Report to the Future Melbourne Committee

Planning Permit Application: TP-2020-570 165-167 Exhibition Street, Melbourne

13 April 2021

Delegated Planning Application Report

Figure 4 – Eastern elevation as per advertised plans

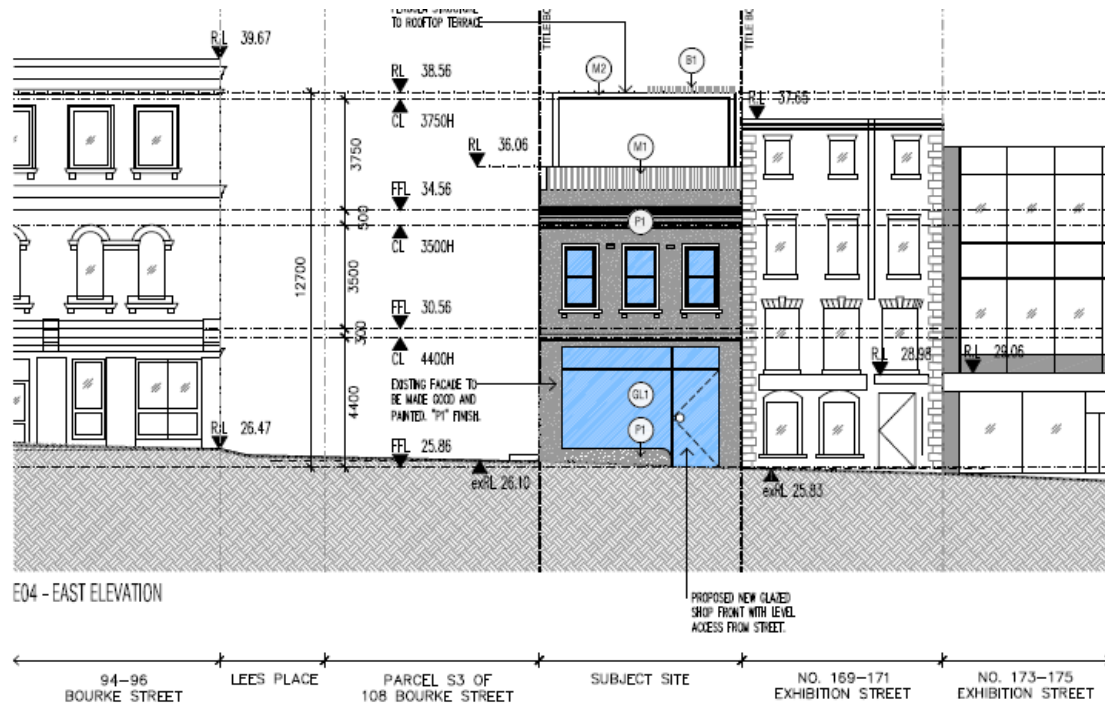
As noted above Amendment C308 is now considered to be seriously entertained. The subject site is identified under Map 1 to proposed Schedule 1 to the Design and Development Overlay as being within the 'Central City' and within the 'Special Character Area'. An assessment of the proposed revised controls is as below:

The development adopts a contemporary response to the proposed extension to the existing heritage building. Street frontage to Exhibition Street does not exceed 25 metres, as such is required to be broken into smaller vertical sections. The proposal also provides a visually recessive upper level which has been setback approximate 12 metres from the street frontage.

Figure 5 – Proposed demolition

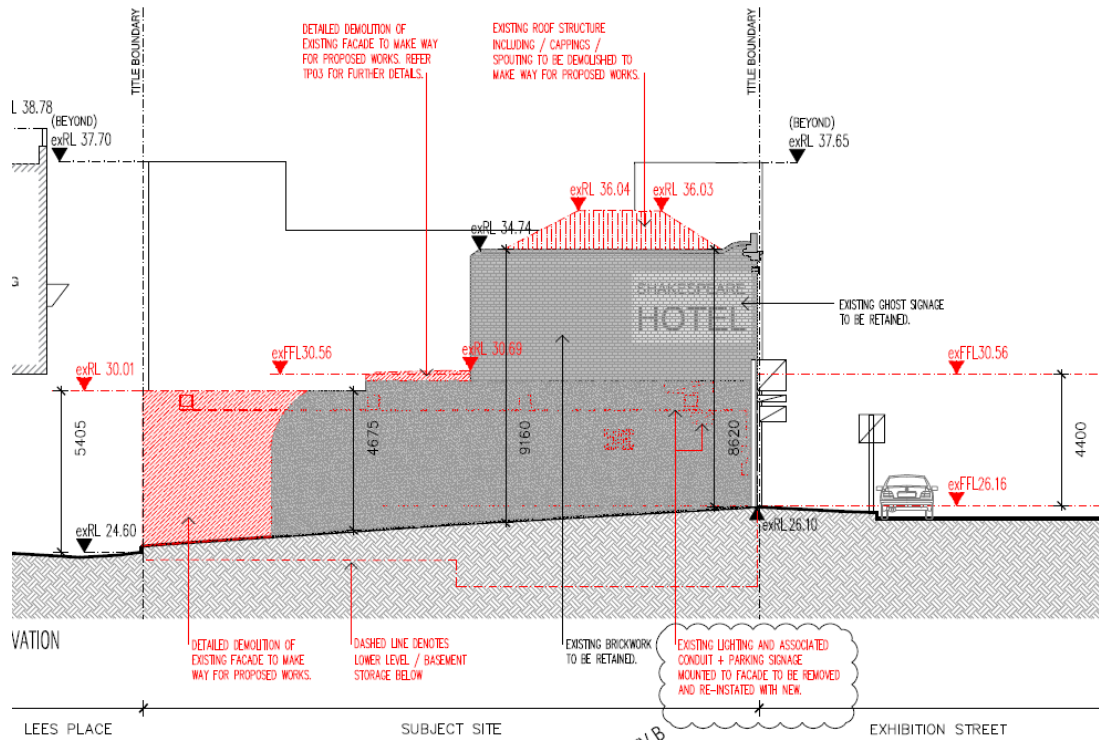
However, the first frame of the rooftop pergola and the sheet metal balustrade are not acceptable as they are prominently visible from the front and side above the retained front of the building, significantly impacting its visual integrity. A permit condition is recommended to set both elements back at least 4m from the street frontage.

The proposed demolition will facilitate the adaptive re-use of the building, whilst maintaining key attributes of the site, and is therefore supported.

Figure 6 – Southern elevation as per advertised plans

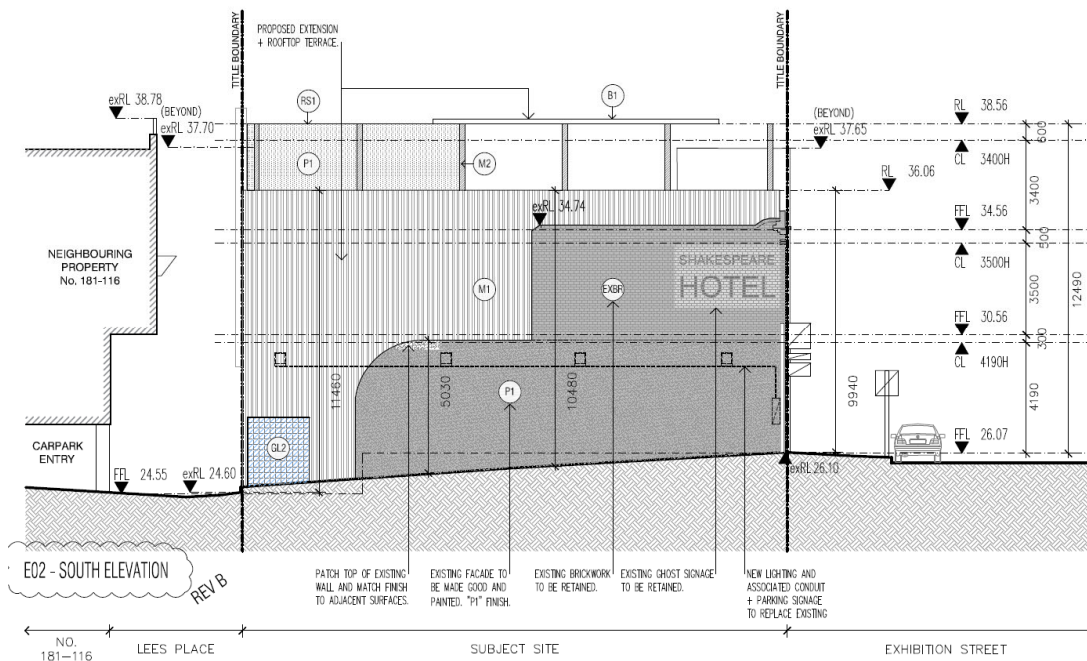
The development generally maintains the existing low scale built form of the immediate surrounds, whilst providing an adaptive reuse to the roof space which is not considered to impact significant heritage fabric. Whilst the rear extension to the first floor to the rear boundary will be visible from Lees Place and south-eastern corner of Exhibition Street the retained portion of the site (to depth of approximately 9.5 metres) will remain prominent. Similarly the second floor which has been setback approximately 12 metres is considered to be recessive.

The southern elevation shows that existing parking signage on the building façade will be replaced; it is noted Council records do not show a permit has been approved for this signage and it has not been included in the permit application. As such a condition will require this notation is removed from plans. Existing lighting along the boundary is not within the Title boundary and will need to be removed.

- c) Material and finishes schedule updated to show:
 - i. 'M1' Metal Cladding' updated to profiled metal cladding; and
 - ii. 'P1 Paint Finish' removed from east and south elevation of retained building, to replace with 'EXBR Existing Brick'.

- d) Deletion of reference to replacement parking signage and public lighting;
 - e) Any changes required by Waste Management Plan under condition 4.

Figure 3 – Eastern elevation as per advertised plans

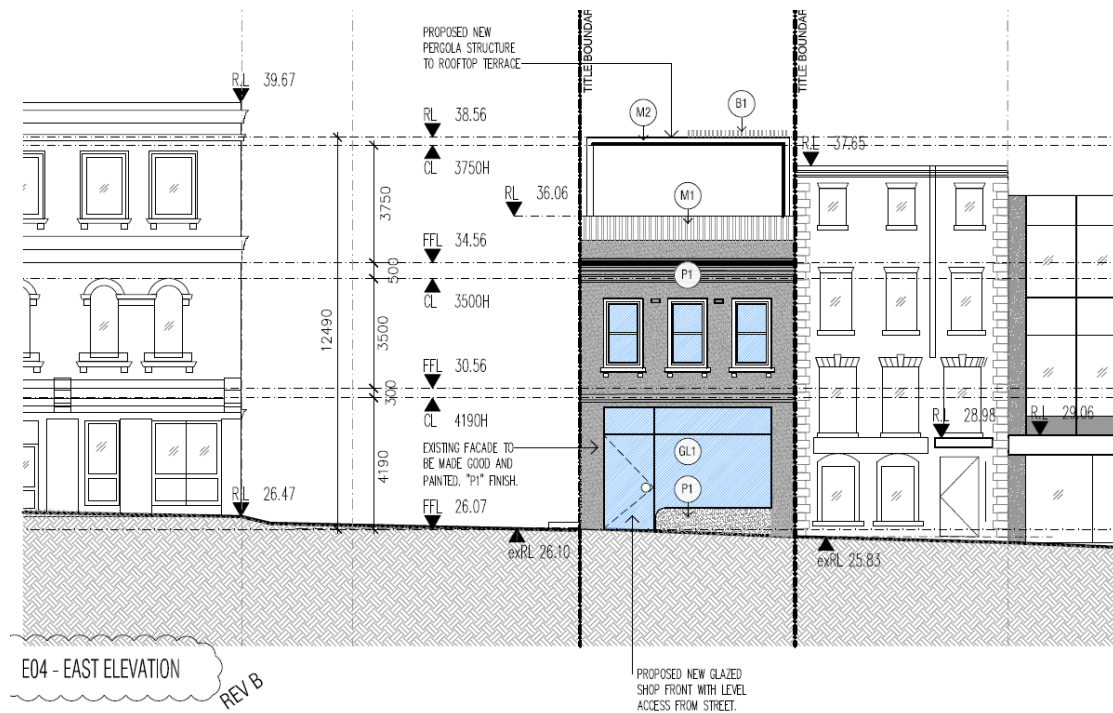
The adjoining site to the south is the only entry point to basement car park of 100-116 Bourke Street, as such is unlikely to be extensively redeveloped however limited weight can be placed on potential future development. It is also considered that if the site to south was development, the front frame will still be an intrusive element and unsympathetic the heritage place. A condition will require the deletion of the front frame element.

The extension is distinctively modern and will juxtapose with the adjoining heritage fabric rather than mimic or replicate it in any literal sense. Conceptually, this approach is the preferred approach to new buildings within heritage precincts.

Figure 7b – Private driveway as viewed from Exhibition Street

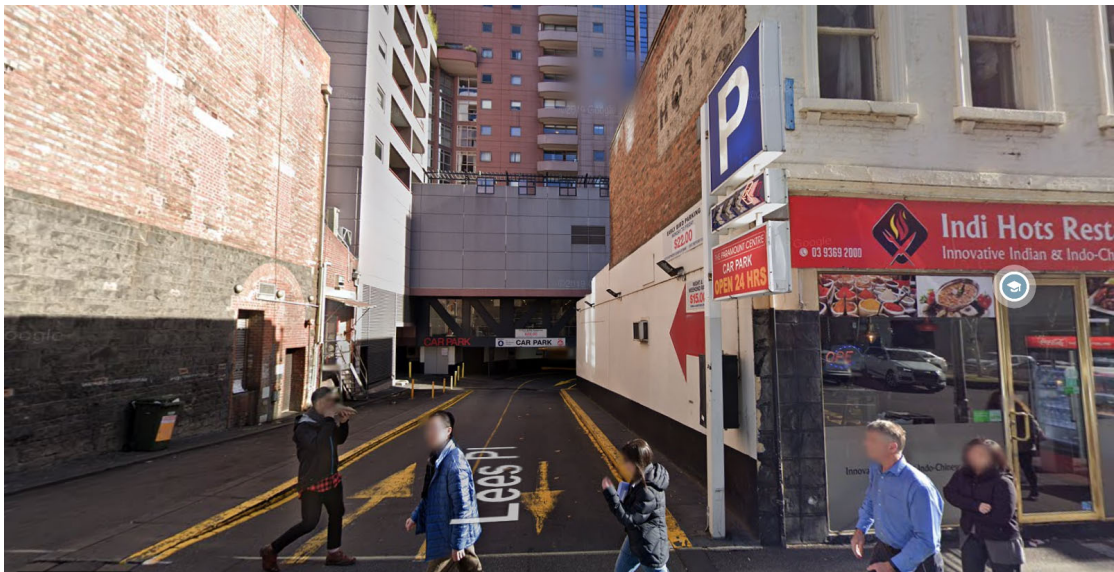
As noted above waste cannot be collected from Lees Place as such revised WMP generally in accordance WMP prepared by Salt dated 9 November 2020 detailing the following is required:

- All bins are to be drawn to scale on the floor plan.
- Provision for the management of organic waste; and
- Waste collection from Little Bourke Street (north end of Lees Place).

4. Prior to the commencement of development, a revised Waste Management Plan (WMP) shall be prepared, submitted and approved by the Melbourne City Council - Engineering Services. This Plan must be generally in accordance with the plans prepared by Salt dated 9 November 2020 but amended to show:
 - a) All bins are drawn to scale on the floor plan;
 - b) Provision for management of organic waste; and
 - c) Waste collection from Little Bourke Street.
